# **MOUND FORT MIDDLE SCHOOL STAGE LIGHTING CONTROLS UPGRADE**

**Electrical Addendum #1**

**Issue Date: 12/20/2023**

SYMBOLS, SCHEDULES AND NOTES

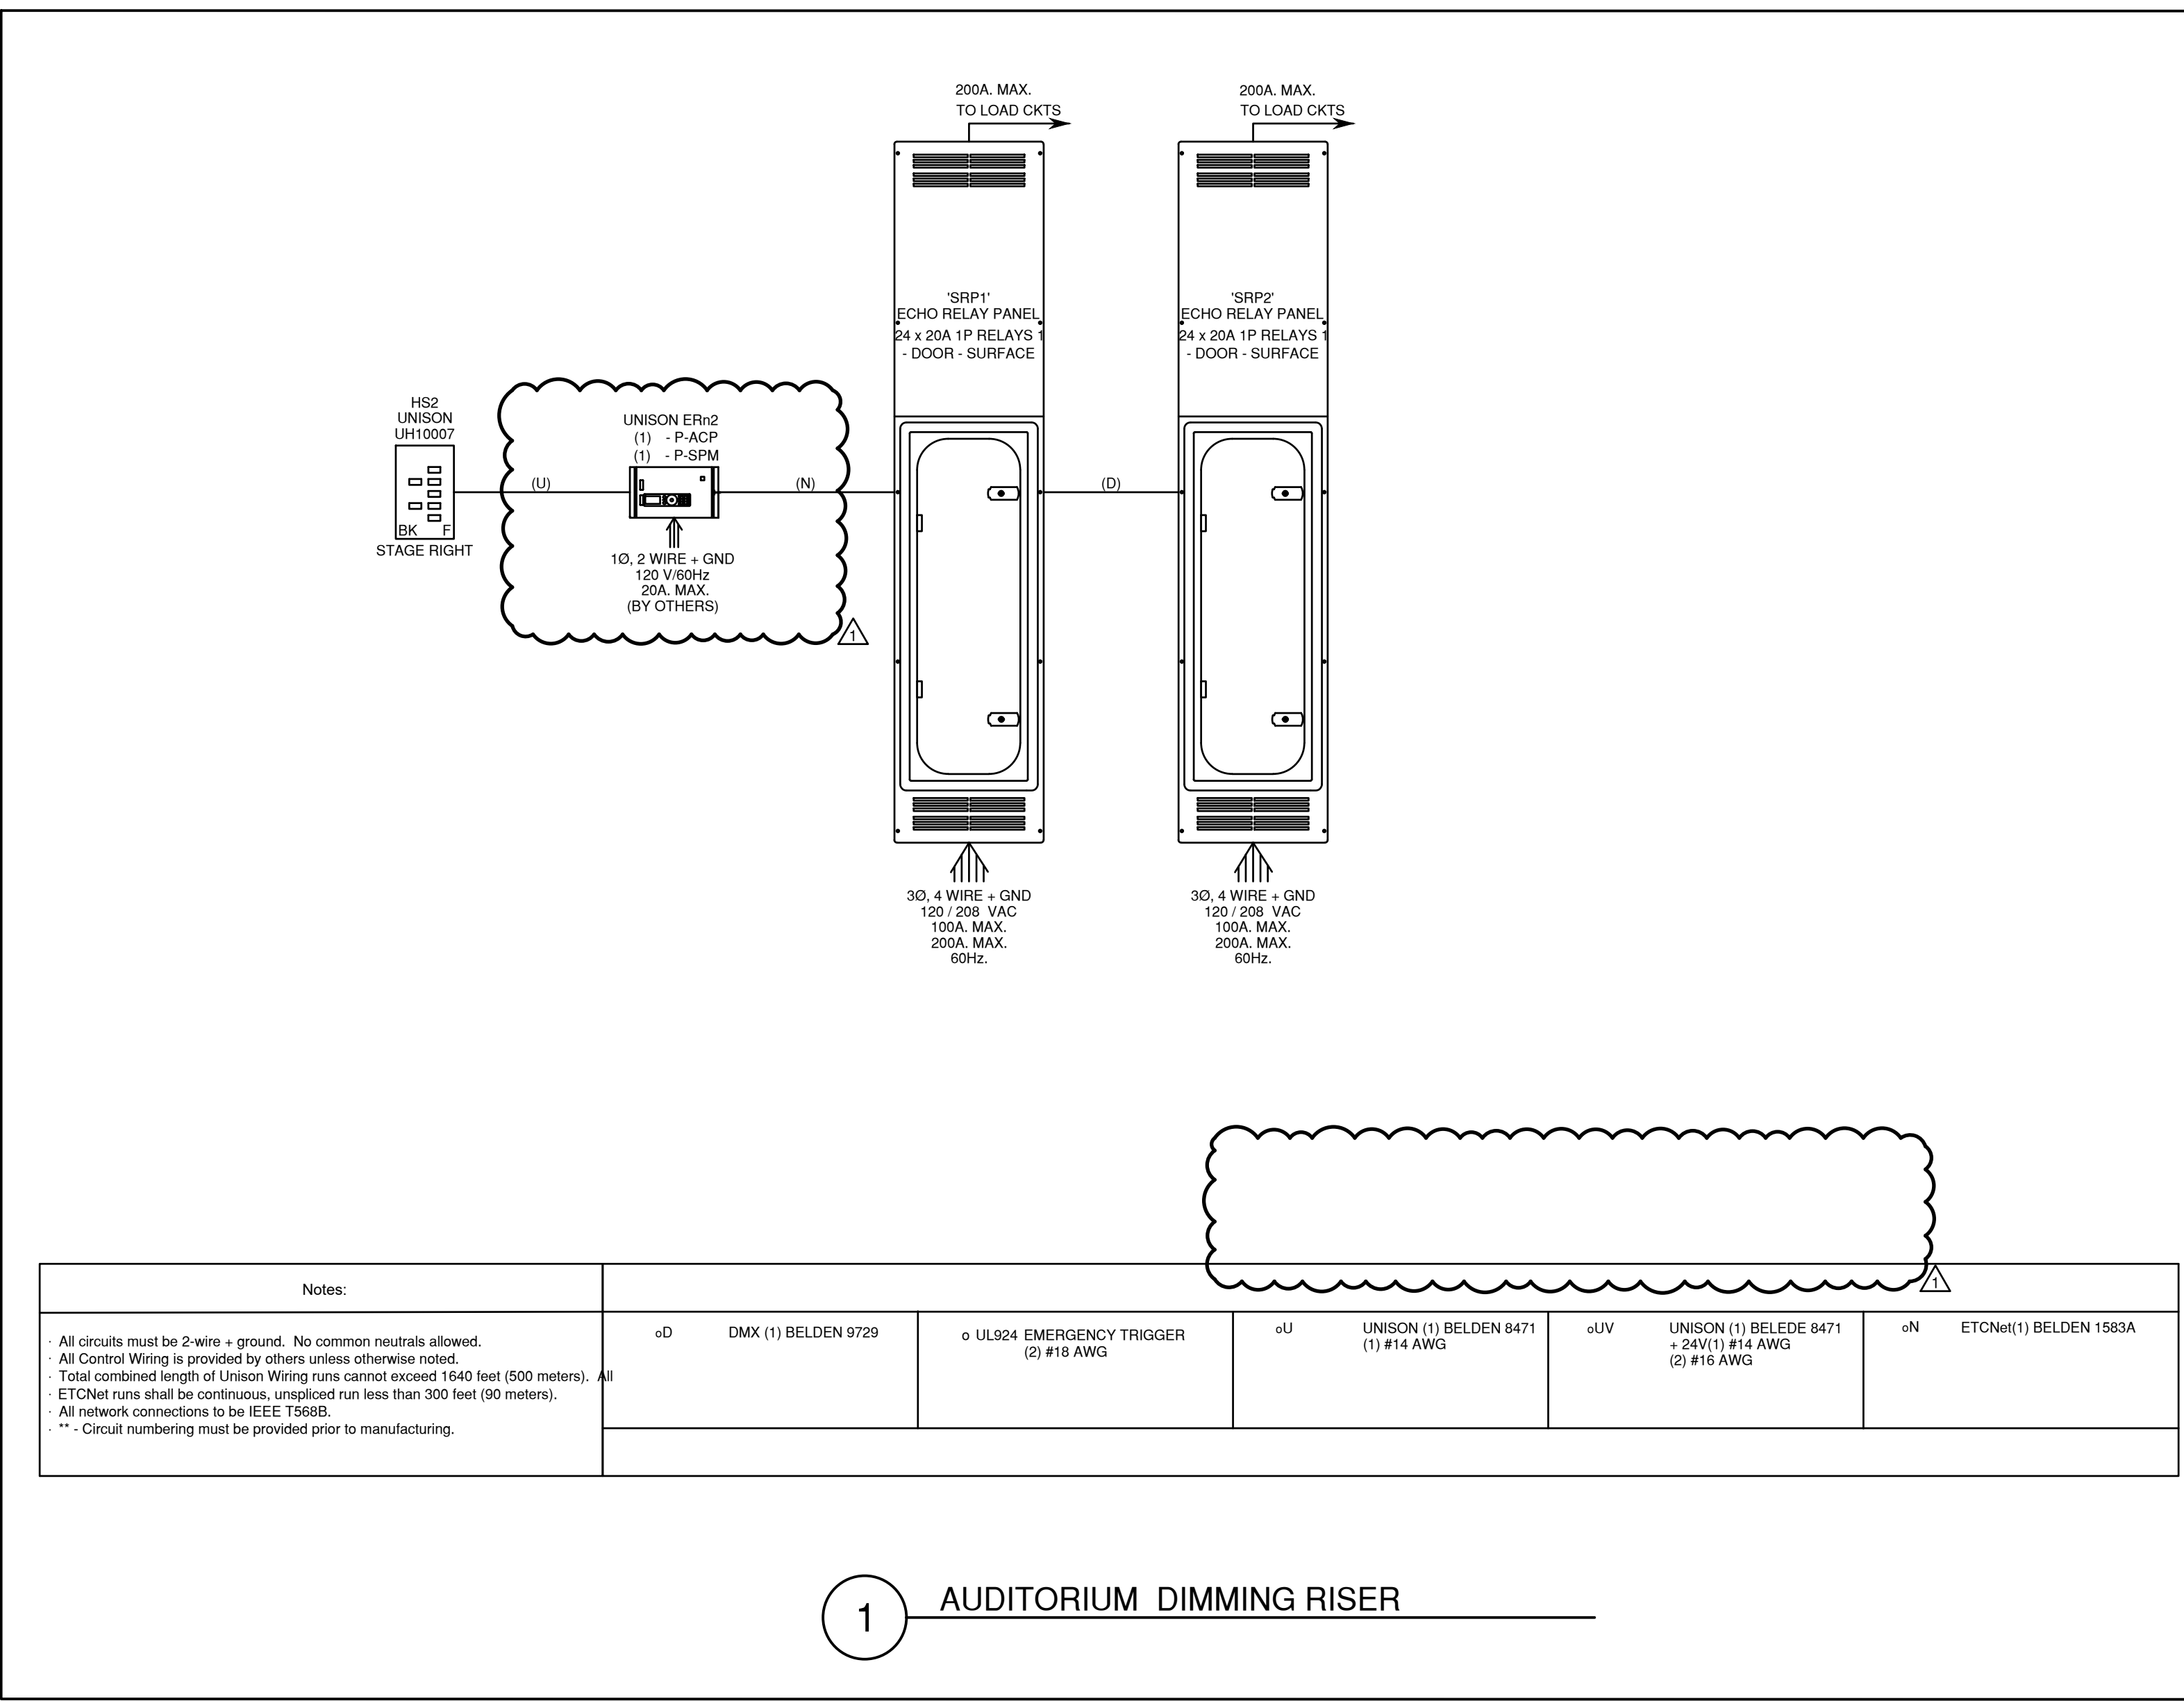
### **SHEET E001**

1. Added the additional house lighting circuits that were discovered during the pre-bid walk.
2. Added the circuits for the lecture spaces at the back of the auditorium.
3. Added an Architectural lighting controls processor to the riser.

**E101**

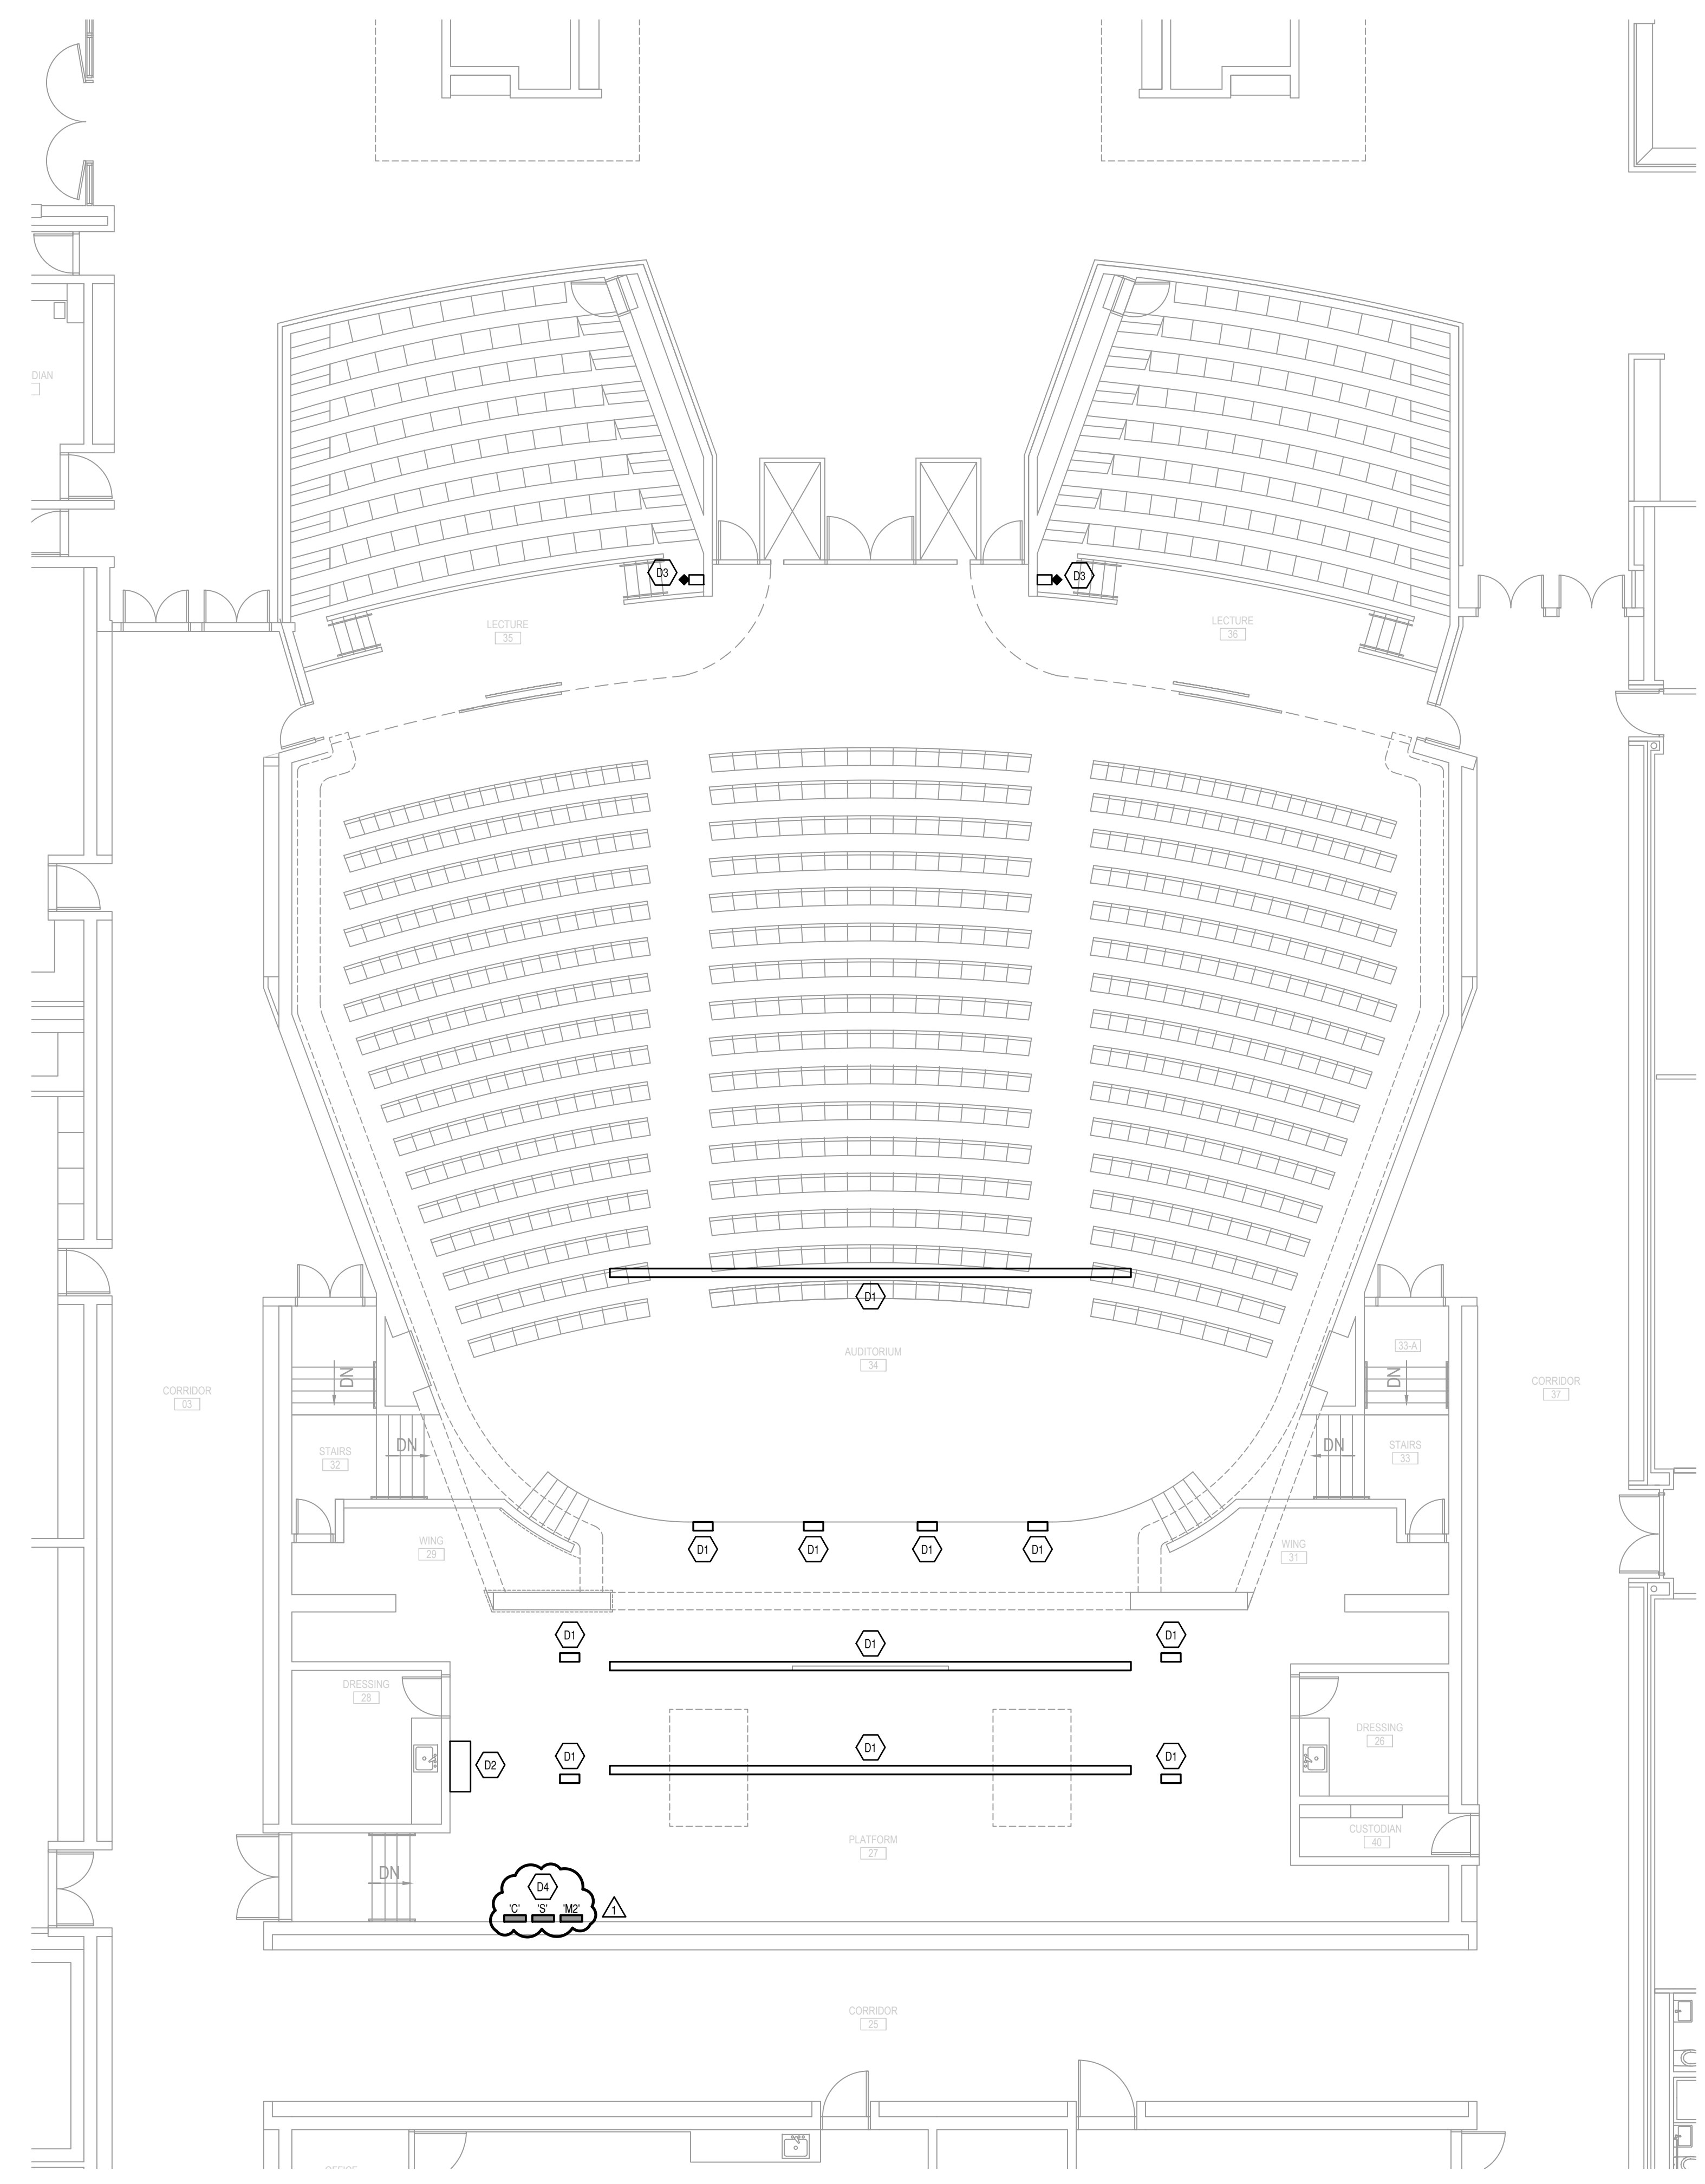
### **SHEET E101**

1. Added the additional panels that are on stage.
2. Updated keynote D2.
3. Added keynote D4.

SHEET KEYNOTES	
D1	EXISTING CONNECTOR STRIPS, OUTLET BOXES AND FLOOR BOXES TO REMAIN. EXISTING WIRING TO REMAIN. REPLACE ANY BROKEN RECEPTACLES AND INSURE ALL ARE IN WORKING ORDER. CIRCUIT QUANTITIES WILL BE REUSED. RE-LABEL ALL CIRCUIT NUMBERS ON CONNECTOR STRIPS BASED ON NEW CIRCUITING.
D2	REMOVE EXISTING DIMMER RACK. EXISTING FEEDERS TO BE REUSED FOR ONE OF THE NEW RELAY PANELS. WHERE POSSIBLE THE EXISTING CONDUITS MAY BE REUSED. EXISTING FENCE ENCLOSURE AROUND DIMMER RACK TO REMAIN.
D3	EXISTING CONTROLS TO BE REMOVED AND JUNCTION BOXES COVERED.
D4	REMOVE EXISTING 350A BREAKER IN PANEL 'S'.
